DOE/RW-0070  
Volume 3 of 3

# Environmental Assessment

*Reference Repository Location,  
Hanford Site, Washington*

COMMENT-RESPONSE DOCUMENT

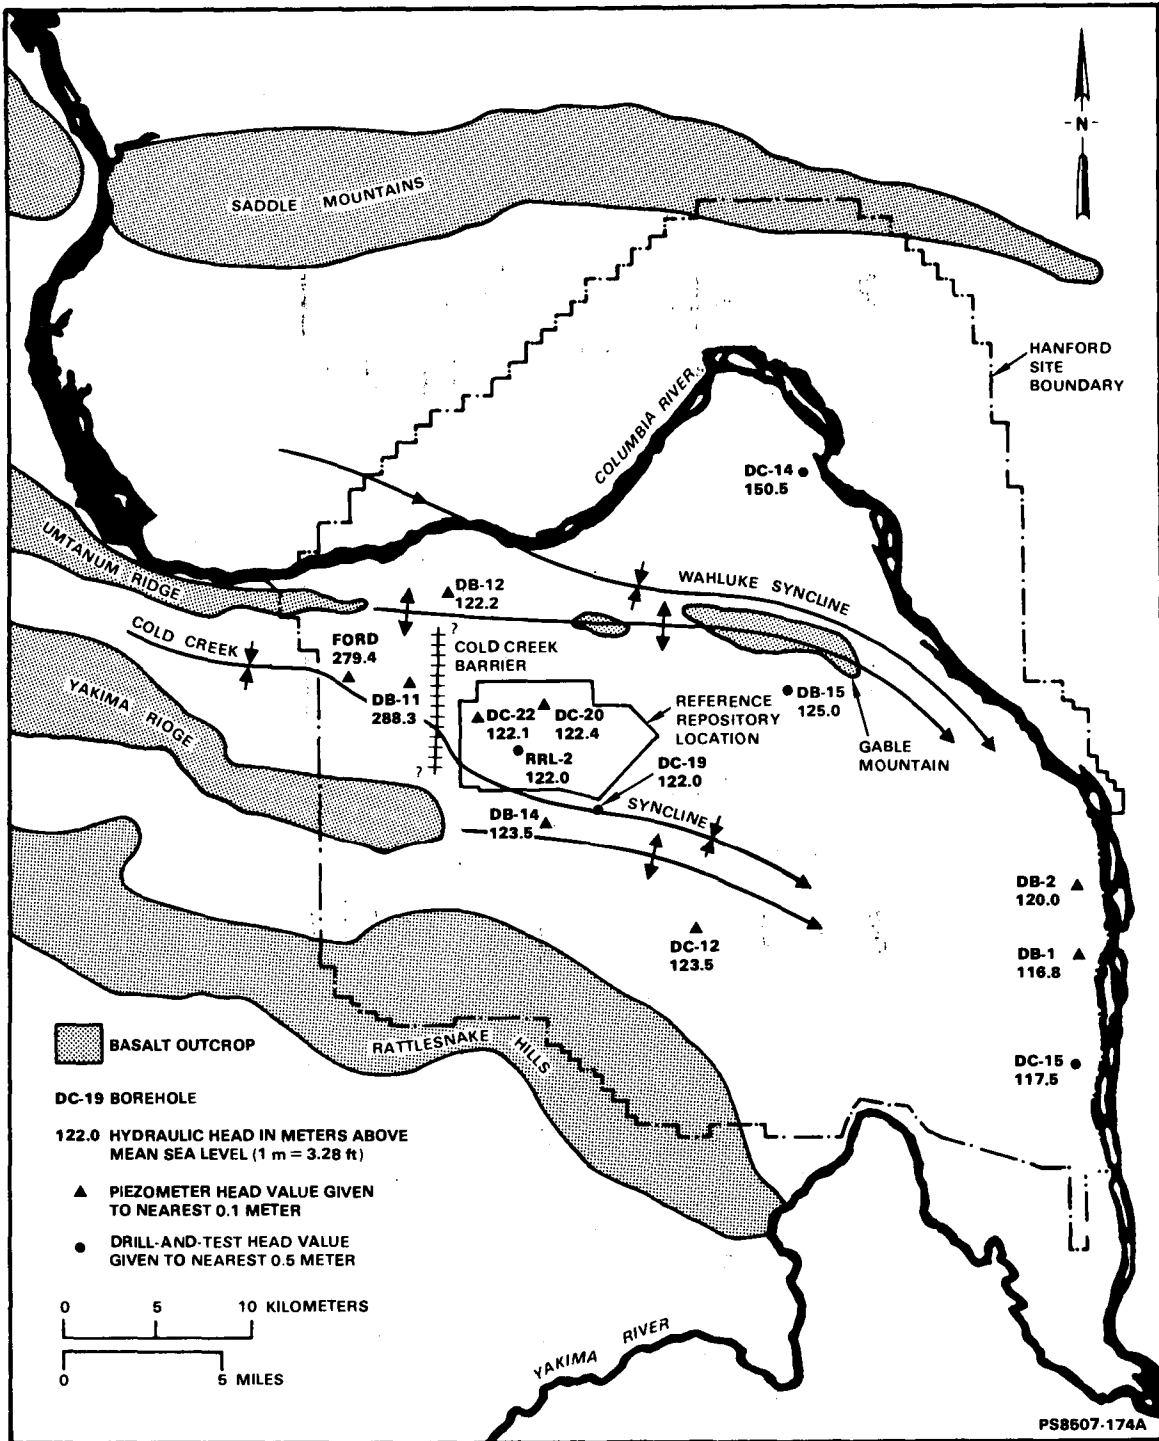
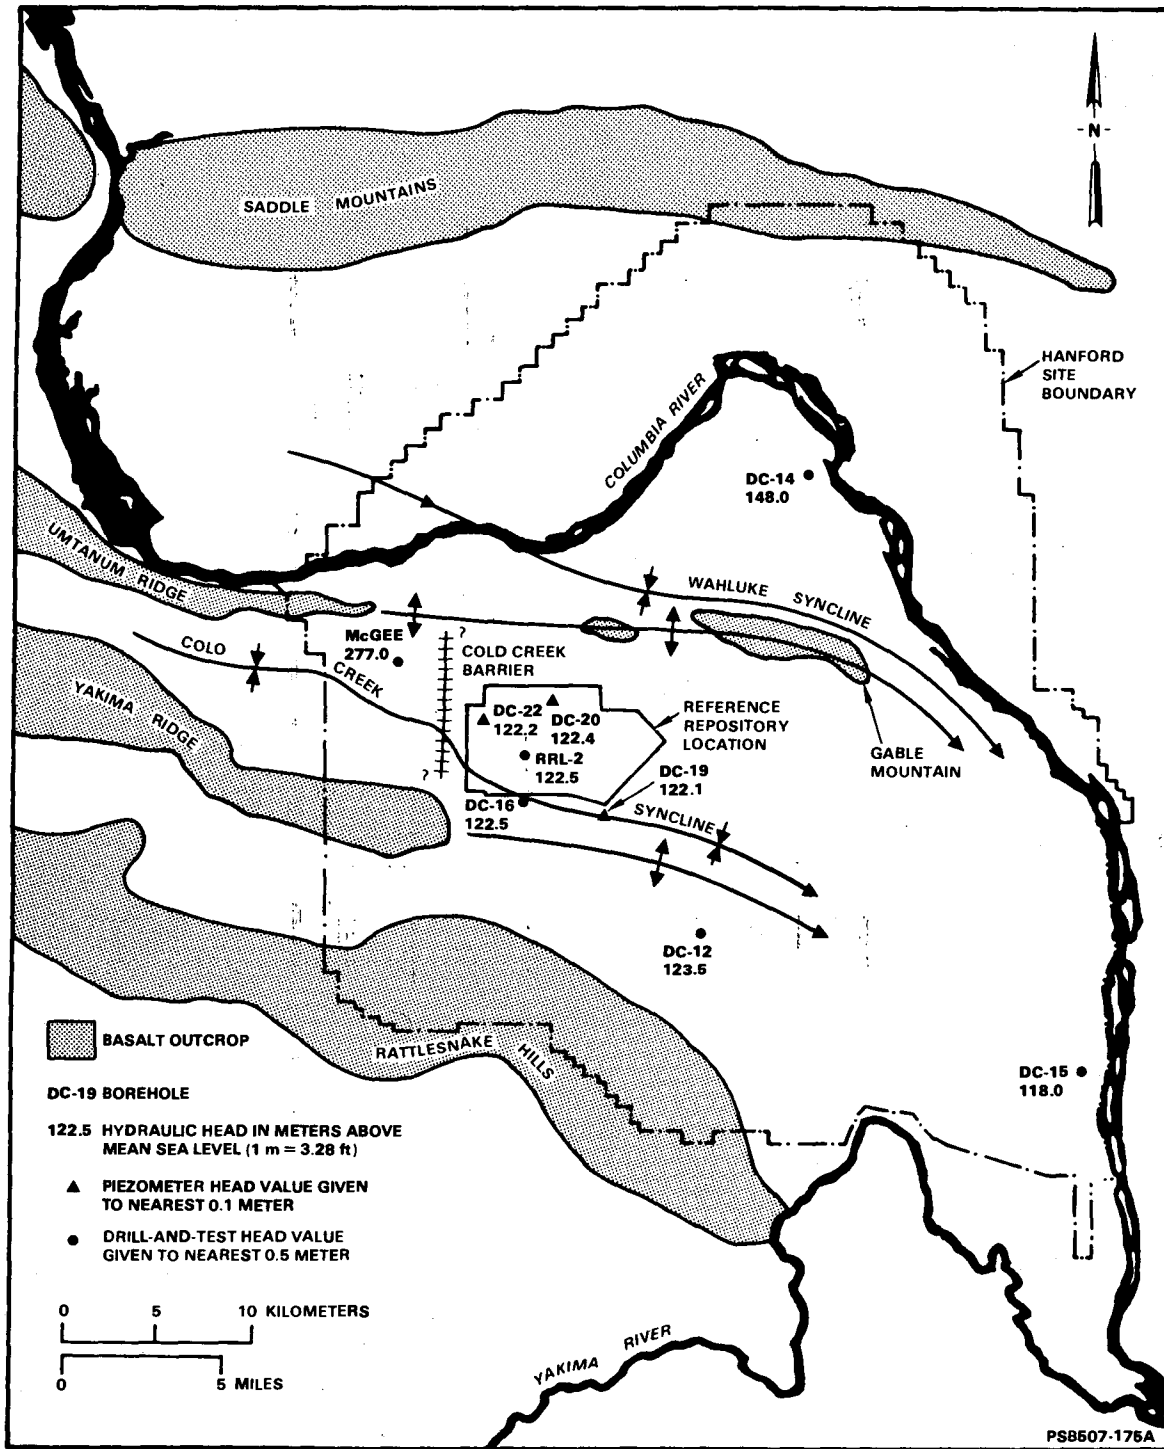
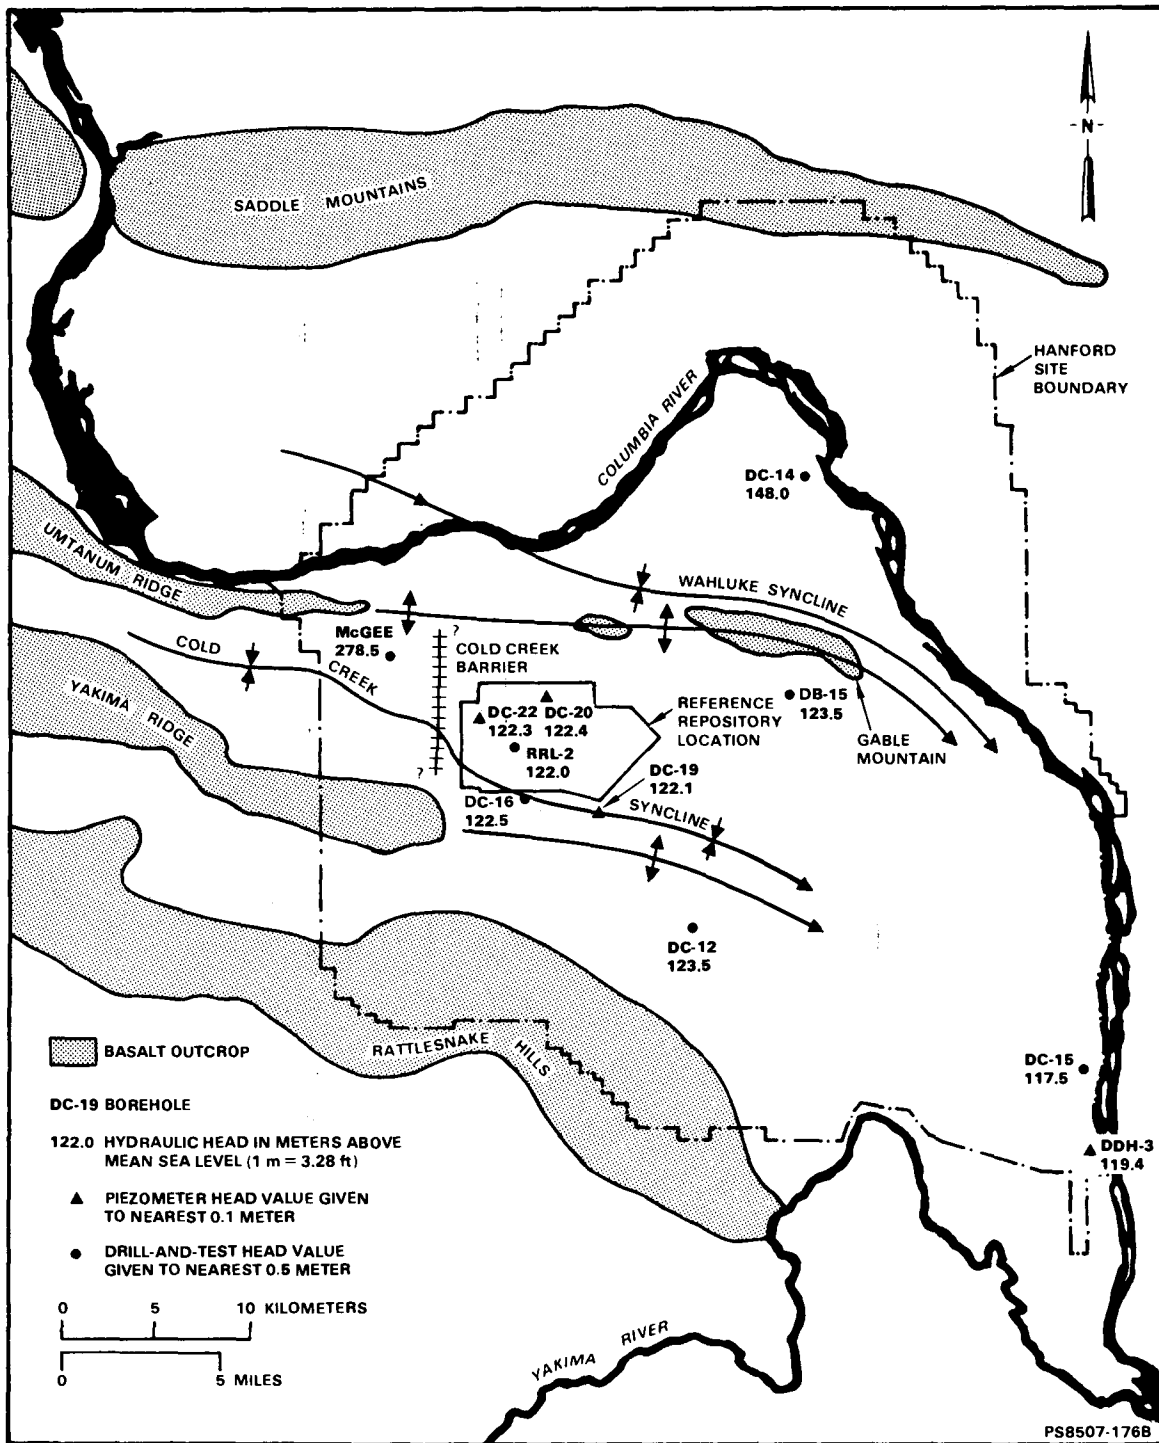
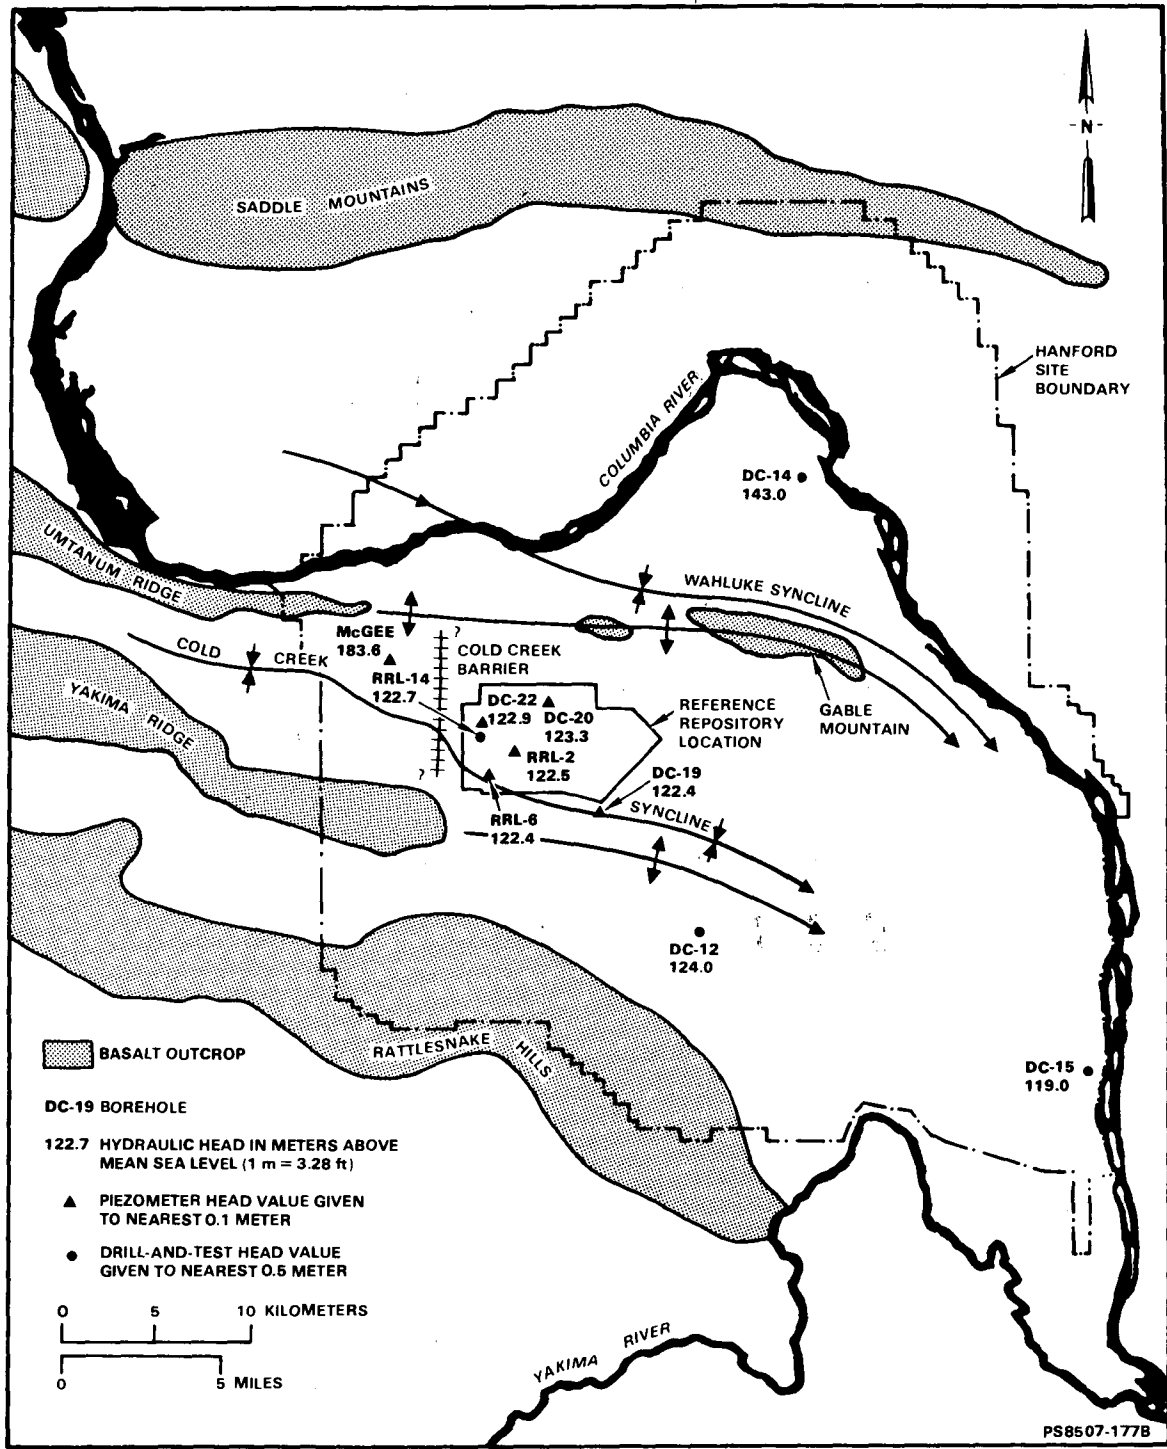
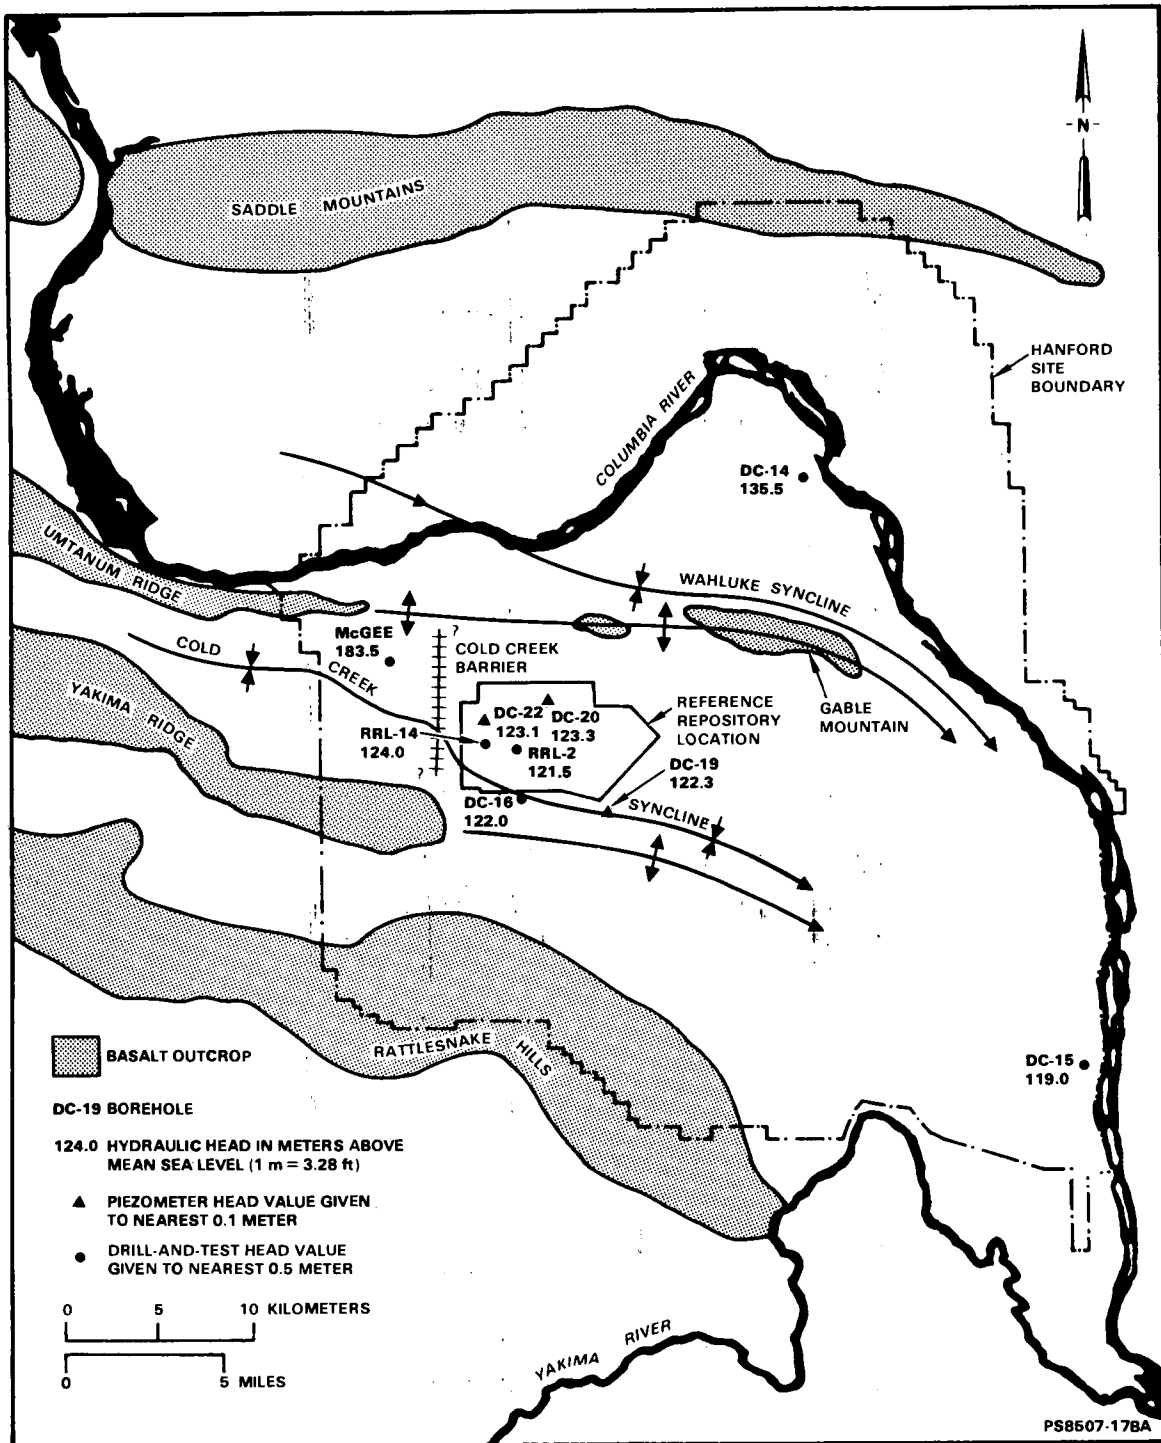
In general, head data indicate flow is from the north side of the Cold Creek syncline to the south side and from northwest to southeast along the synclinal axis. As shown, the axis of the Cold Creek syncline lies close to the Yakima Ridge anticlinal axis. Large head values west of the upper Cold Creek flow impediment (Cold Creek barrier) reflect the resistance to southeasterly flow provided by the impediment. Thus, contrary to the commenter's statements, head data from the drill-and-test program combined with that from boreholes DC-19, DC-20, and DC-22 for the major flow tops do provide a reasonable, general areal pattern of ground-water flow in the Cold Creek syncline. Head data gathered during the drill-and-test program do not present a confusing picture with regard to movement of water as long as one uses values that were well equilibrated.
